VALVE ELECTRONIC **CV2272**

ADMIRALTY SIGNAL AND RADAR ESTABLISHMENT

Specification AD/CV2272 Issue No. 4 Dated : 14.2.55 To be read in conjunction with K1001	SECURITY Specification: Unclassified Valve: Unclassified

ELECTRONIC VALVE SPECIFICATIONS .
SPECIFICATION AD/CV2272 ISSUE NO. 4 DATED 14.2.55
AMENDMENT NO. 1

CV2272/1/IV

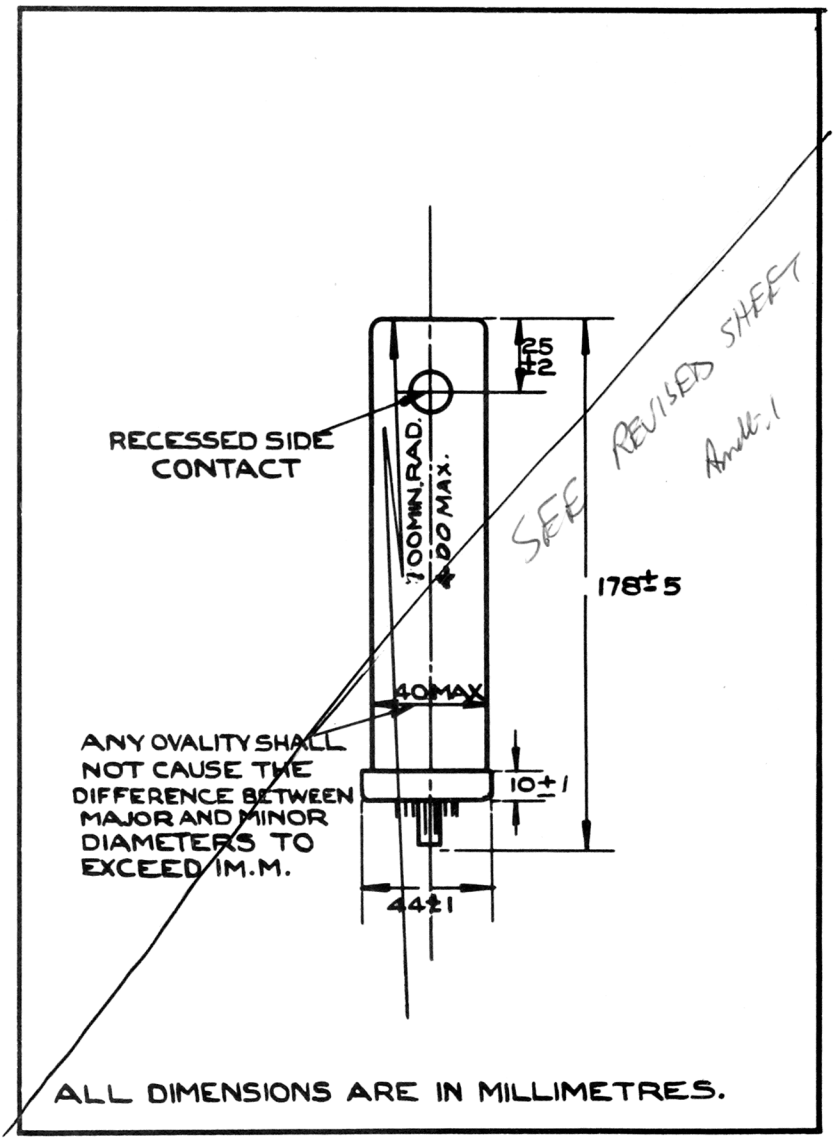
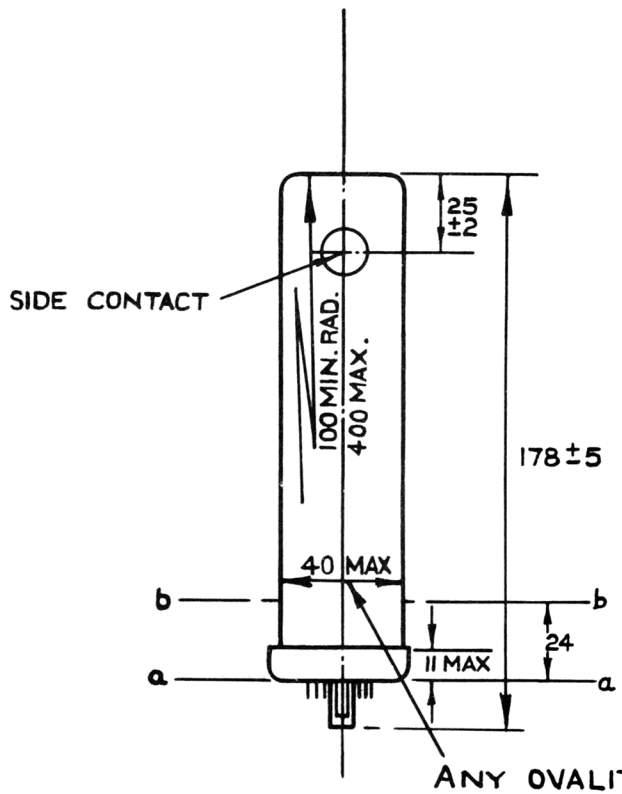
Page 4. Outline Drawing.
Cancel but do not destroy existing Page 4 and substitute new Page 4 attached hereto.

RECESSED SIDE CONTACT
1.00MIN.RAD.
4.00 MAX.
25±2
178±5
40 MAX
10±1
44±1
ANY OVALITY SHALL NOT CAUSE THE DIFFERENCE BETWEEN MAJOR AND MINOR DIAMETERS TO EXCEED 1M.M.
SEE REVISED SHEET Amdt. 1
ALL DIMENSIONS ARE IN MILLIMETRES.

OVER THE DISTANCE a-a TO b-b THE DIAMETER SHALL BE 40 ±2 m.m. EXCEPT THAT FOR A DISTANCE OF 11 m.m. MAX. FROM a-a IT MAY BE 44 ± 1 m.m.
